RE: April 1993 Monthly Progress Report on Remedial Activities at the Former Hexcel Site
205 Main Street, Lodi Borough
Bergen County, New Jersey
ECRA Case No. 86009

G. RESPONSE TO MAY 4, 1993 LETTER FROM THE NJDEPE

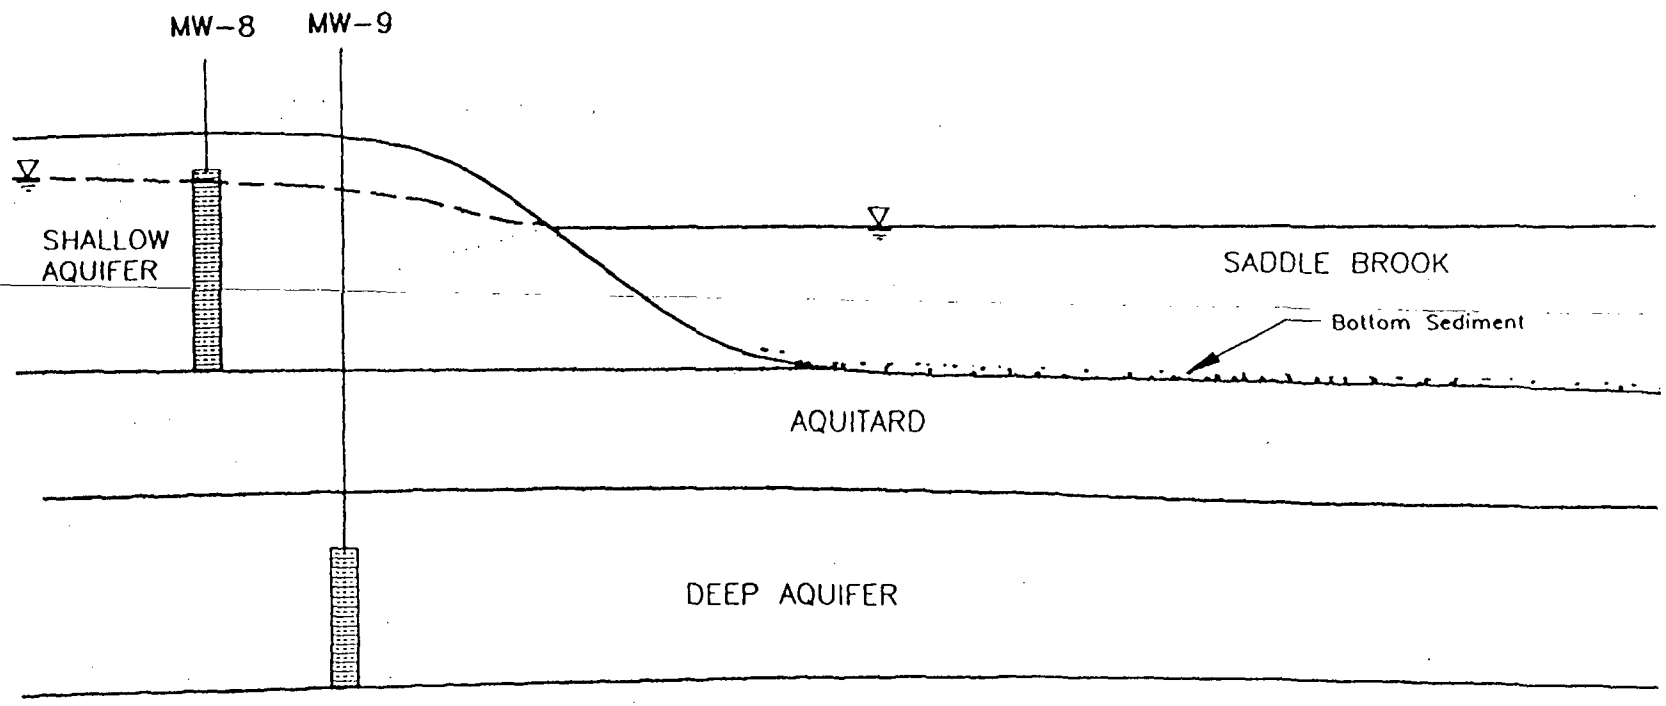
d. *Hexcel failed to implement Conditions 21C.1 of the Cleanup Plan Approval letter dated July 31, 1990 (Cleanup Plan Approval) for investigation of Areas 1, 5, 6, 8, and 13.*

Area 8: Soil boring 1401 has already been drilled on the building side of the sewer pit and appears to satisfy this requirement. The locations of the boring and the sewer are indicated in Figure 1.
